RE: Comment Letter to RDEIR/S – California Water Fix

**SolAgra Water Solution – previously known as: West Delta Intake Plan
Viable Alternative to BDCP/ CWF**

SUBJECT: Technical Comments on Bay-Delta Conservation Plan Modeling

Figure 1. Inflow to Trinity, Shasta, Oroville, and Folsom Reservoirs – NAA, NAA-ELT and NAA-LLT

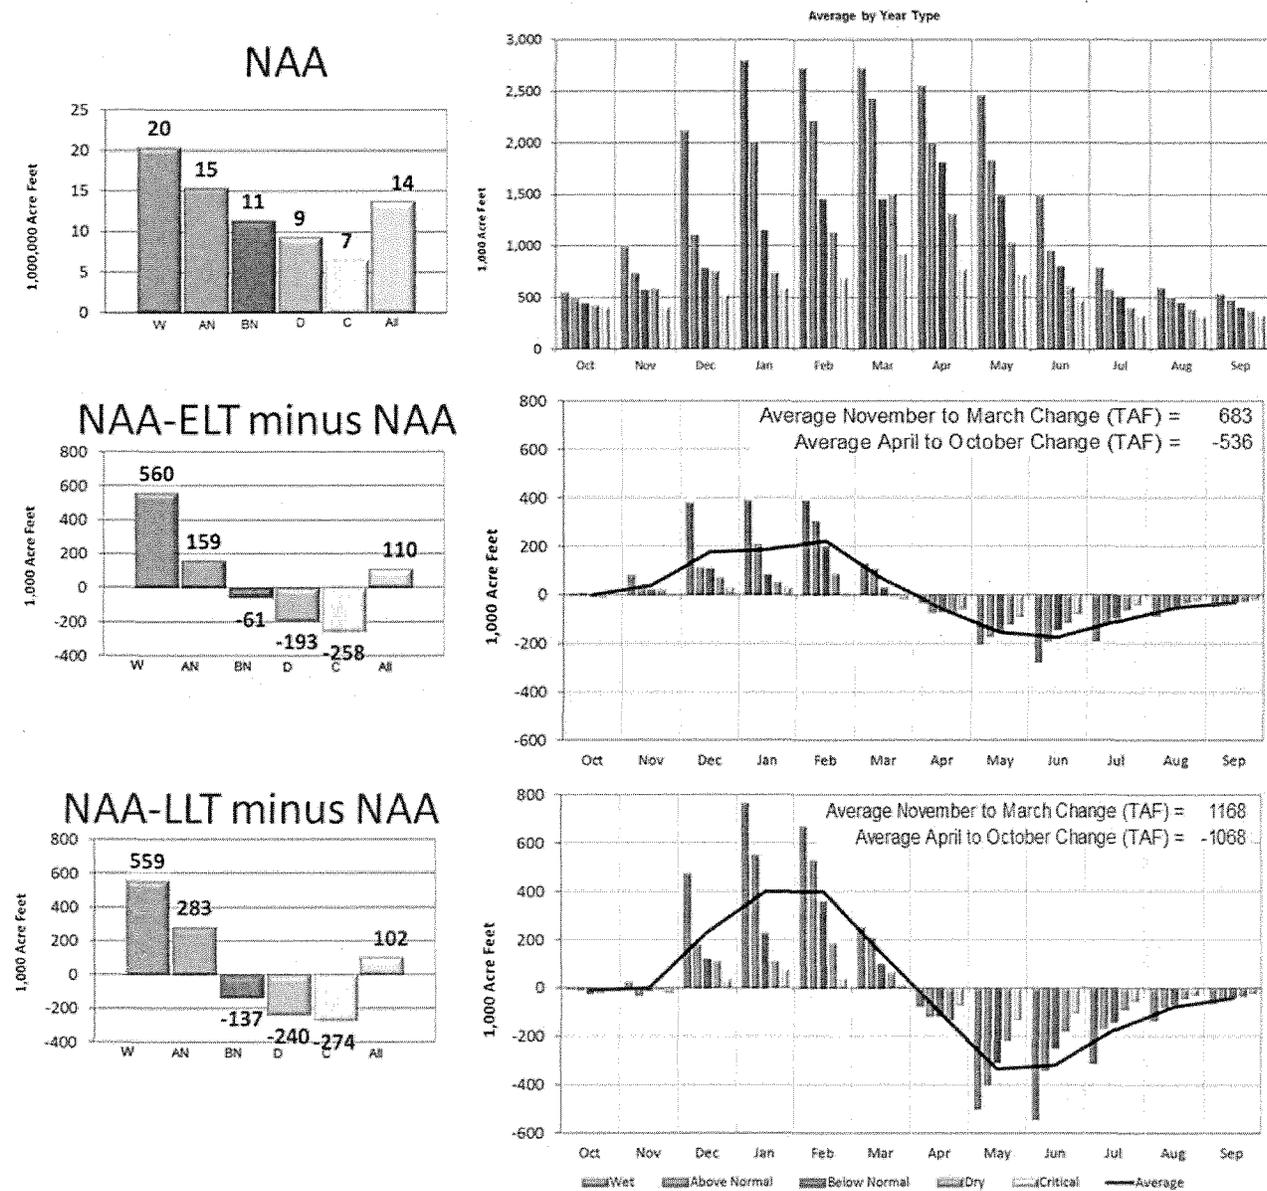
Comparison of inflow changes illustrated in Figure 1 and Figure 2 show the effects of climate change are large in the American River Basin relative to changes in other river basins. Total changes illustrated in

Figure 1 show wetter conditions in wet years and drier conditions in dry years when considering the four basins together. However, climate change in the American River Basin for the LLT shows drier conditions in all year-types. Additionally, a large percentage of the dry and critical year inflow reduction, 57 and 37 percent respectively, for the combined four basins occur in the American River Basin. By comparison, runoff from the American River at Folsom is approximately 20 percent of the sum of runoff of the Trinity, Sacramento, Feather, and American rivers.

Figure 2. Projected Inflow to Folsom Reservoir – NAA, NAA-ELT and NAA-LLT

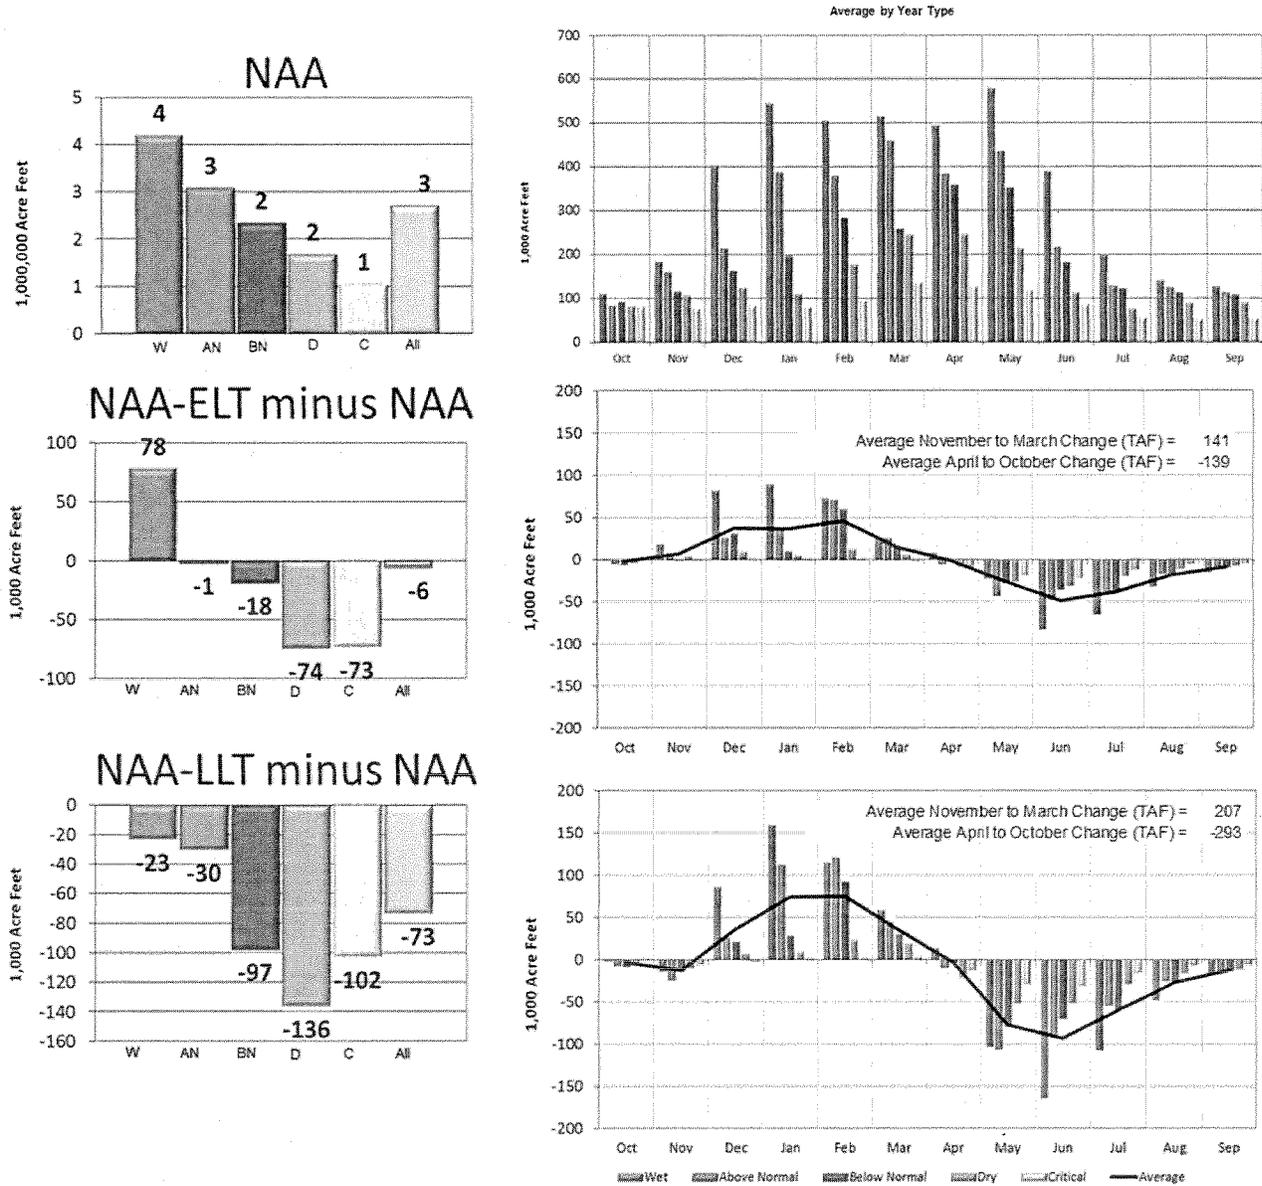
The effect of assumed climate change on average annual Folsom Reservoir inflow in the NAA-ELT scenario is minor, but causes decreases in inflow of about 70 TAF in the NAA-LLT scenario. The spring to winter shift in runoff is also projected for Folsom Reservoir inflow. Figure 2 is an illustration of Folsom inflow under the NAA and the change relative to NAA for the NAA-ELT and NAA-LLT baselines. To properly incorporate climate change into modeling of Folsom Reservoir and the American River, climate change effects must be applied to flows and reservoirs upstream from Folsom, which was not done. There is significant storage capacity in the upper American River watershed in PCWA’s Middle Fork Project and the Sacramento Municipal Utility District’s (SMUD) Upper American River Project. The

operation of Folsom is significantly affected by changes in upstream conditions and operations.⁹ Because climate change in BDCP modeling is imposed on the American River by adjusting only the inflow to Folsom only, however, the effect on the American River is likely misrepresented in the BDCP NAA-ELT and NAA-LLT scenarios.

Figure 3. Folsom Reservoir Carryover Storage

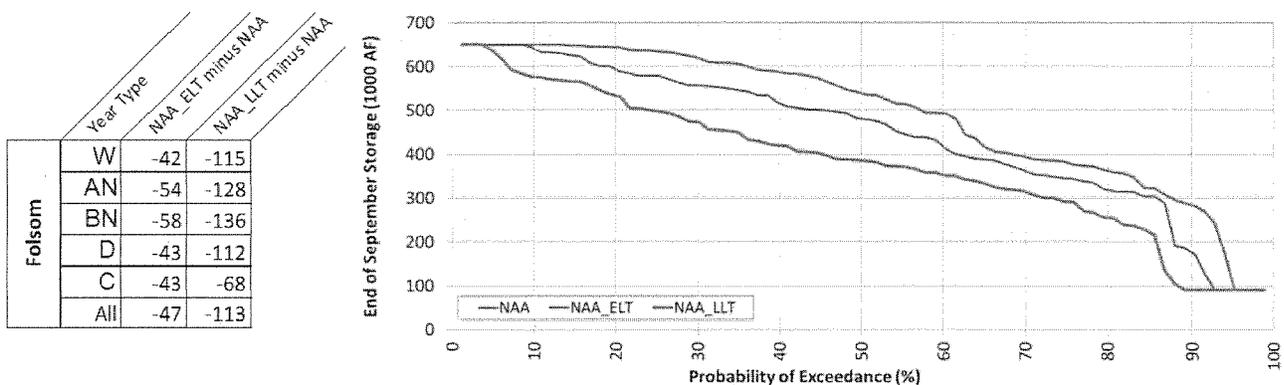
For Folsom and other upstream CVP and SWP reservoirs, the shift of in timing of inflows along with a continuing need to satisfy downstream environmental requirements and demands significantly affects carryover storage. Because of climate change’s assumed effect on hydrology and the lack of CVP/SWP operational adaptations in the BDCP modeling, the CVP and SWP simply cannot satisfy water demands and regulatory criteria imposed on them in the NAA-ELT and NAA-LLT modeling scenarios. Figure 3 illustrates change in carryover storage in Folsom Reservoir. The relatively high frequency (approximately 10% of time) of minimum storage occurring at Folsom Reservoir leads us to question whether the NAAs reflect credible or defensible operations. The projected occurrences of low and dead storage conditions projected by the BDCP modeling result in severe reduction of flow available to sustain habitat in the Lower American River and severe reductions in water supply reliability.

Figure 4. CVP North of Delta M&I Water Service Contract Allocation

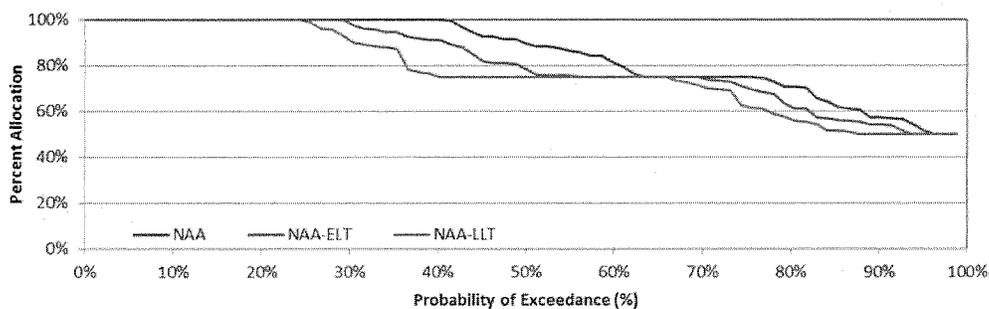
Assumed effects of climate change and lack of adaptation reduces CVP water supply allocations to American River CVP Water Service Contractors. Figure 4 contains exceedance probability plots of CVP M&I allocations for the NAA, NAA-ELT, and NAA-LLT scenarios. Full allocations are made 40% of the time under the NAA, this is reduced to about 30% in the NAA-ELT, and full allocations are made about 25% of the time in the NAA-LLT. The occurrence of 50% allocation increases from about 4% in the NAA to about 7% in the NAA-ELT and to about 12% in the NAA-LLT. In addition to reduced water service contract allocations, water supply allocations under any right cannot be satisfied due to low storage levels in Folsom Reservoir and low flow in the Lower American River. It is not physically possible to divert water for M&I use from Folsom Reservoir when reservoir storage drops below about 100,000 acre-feet because, at that level, the M&I intake in the reservoir would be dry. In addition, flows in the lower American River below about 500 cfs make it impossible for the City of Sacramento to divert water at its Fairbairn diversion. The water-supply and other effects of these physical conditions occurring in the NAA scenarios are not identified or evaluated in the draft BDCP EIR/EIS.

Figure 5. NAA-LLT and Alt 4-LLT Simulated Folsom Reservoir Elevation

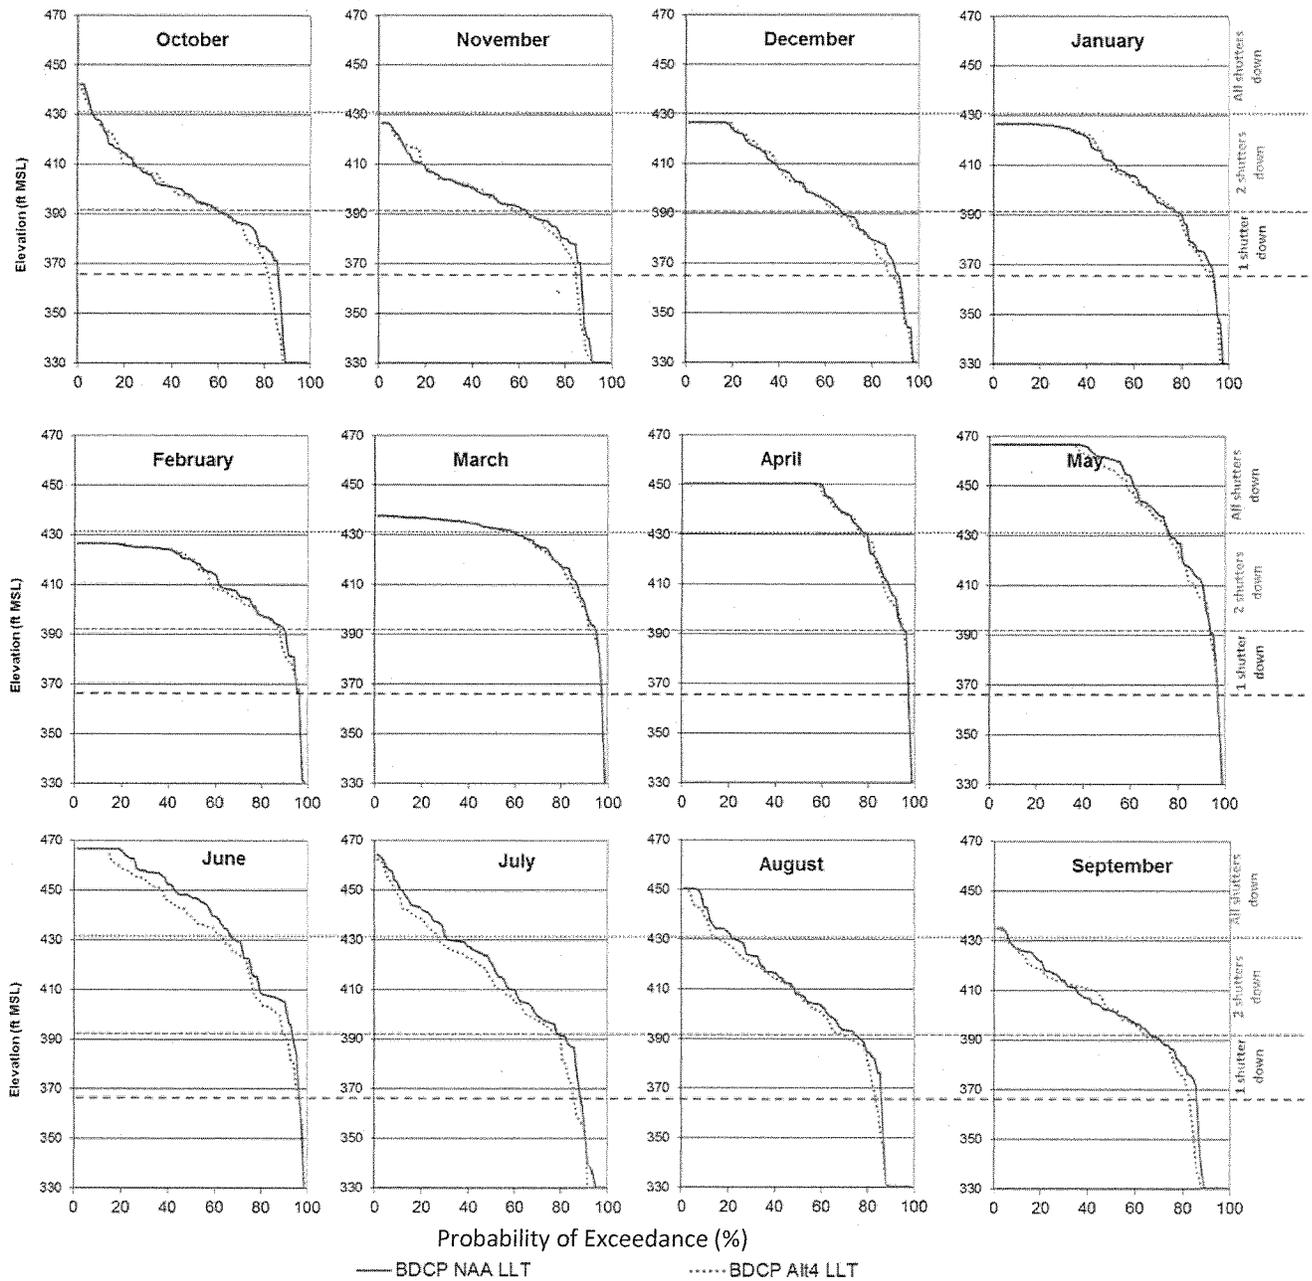
Figure 5 is a comparison of simulated monthly Folsom Reservoir water surface elevations for the baseline and with-Project scenarios. A probability of exceedance chart for each month illustrates differences between the two model simulations and potential Project effects. Dashed horizontal lines indicate water surface elevations when groups of shutters on the intake device must be removed. For example, when the water surface elevation goes below approximately 430 feet, the first group of shutters must be removed. These lines are 30 feet above the top of shutter elevations for the three groups of shutters to account for water depth to prevent the formation of a vortex and cavitation at the intake which would prevent diversion.

Results presented in Figure 5 illustrate that Folsom Reservoir water surface elevation is lower under the with-Project scenario. The largest difference in Folsom elevation occurs from June through August and can affect temperature management by changing when shutters are removed. Shutters are removed from Folsom Dam's intakes in order to access colder water located lower in the reservoir. While removing shutters causes the temperature of water diverted and released from the reservoir to drop almost immediately, that effect does not cause release temperatures to remain cooler indefinitely. Accordingly shutters must be removed strategically.

The timing of shutter removal at Folsom Reservoir would change in the with-project condition. For example, in August the probability of all three shutters being in use is reduced from approximately 25 percent to 15 percent, and the probability of at least one shutter still in used is reduced from approximately 90 percent to 85 percent. Figure 6 is a comparison of simulated monthly Folsom

Figure 6. NAA-LLT and Alt 4-LLT Simulated Folsom Reservoir Storage

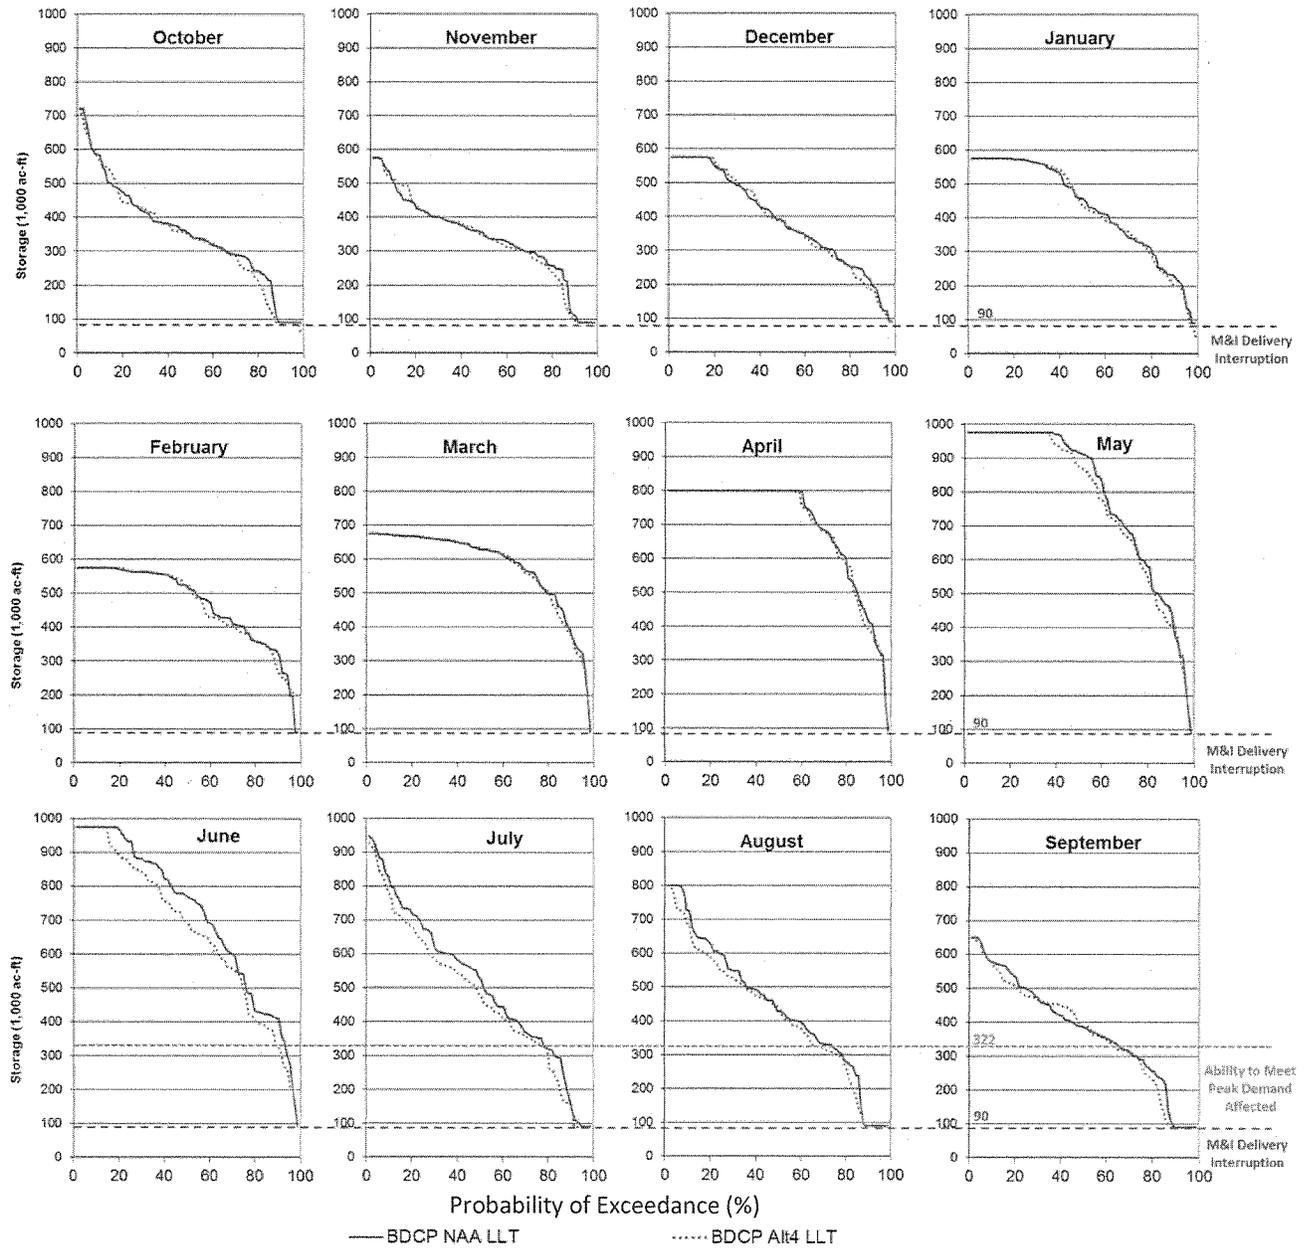
Reservoir storage for the baseline and with-Project scenarios. A probability of exceedance chart for each month illustrates differences between the two model simulations and potential Project effects. Dashed horizontal lines in Figure 6 represent storage levels below which M&I water purveyors cannot meet peak demands (322 TAF) with diversions from Folsom (illustrated for peak demand months only) or when M&I diversions are interrupted because water levels in Folsom are below the M&I intake (90 TAF). Results summarized in Figure 6 show that Folsom Reservoir storage is more likely to be lower under the BDCP Alt4-LLT than the NAA-LLT particularly in peak summer months. Lower storage impacts the ability of the water purveyors that divert directly from Folsom Reservoir, as well as downstream purveyors on the American River, to meet peak demands in the summer and increases the probability of M&I delivery interruptions.

Figure 7. NAA-LLT and Alt 4-LLT Simulated Nimbus Release

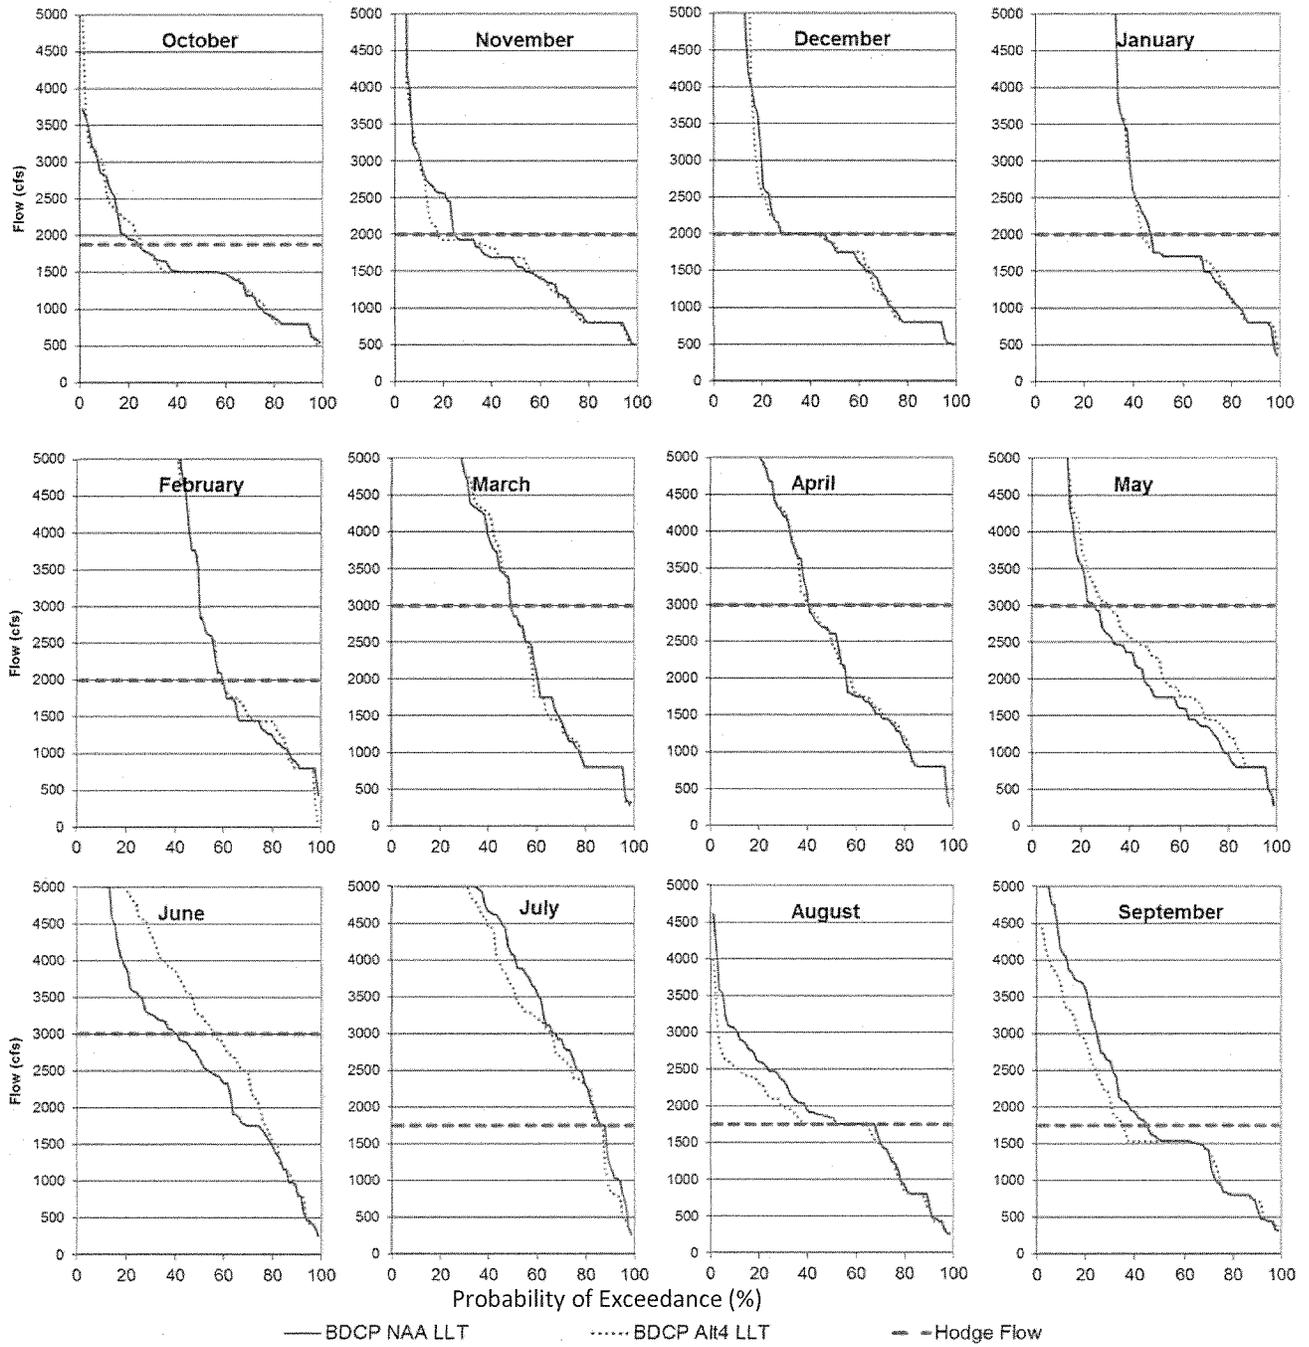
Figure 7 and Figure 8 contain comparisons of simulated monthly flow at Nimbus and H Street for the NAA-LLT and Alt4-LLT scenarios. Results show that under the Alt4-LLT American River flow is higher in the months of May and June, and lower in July, August, and September. Higher releases in May and June drive changes in Folsom storage and water surface elevation seen in previous figures. Likewise, lower releases from July through September bring simulated end-of-September storage between the baseline and with-Project scenarios closer. BDCP modeling shows a higher probability of Lower American River flows being above Hodge Flows in May and June and a higher probability of flows being below Hodge Flows in July, August, and September. When Nimbus releases are below Hodge Flows, diversion limitations under the City of Sacramento's American River water right permits for the Fairbarn Water Treatment Plant on the American River constrain the amount of water available to divert. The changes in American River flows will affect the location of the City of Sacramento's diversion, but this is not reflected in the BDCP modeling. There are also limitations on the City's Sacramento River diversion capability, which could interfere with any such shift in the location of diversions, and hence reduce the supply available to the City. This is not reflected in the BDCP modeling. In the Alt 4-LLT the City of Sacramento will be able to divert more water from the American River at Fairbairn during May and June and less during August and September.
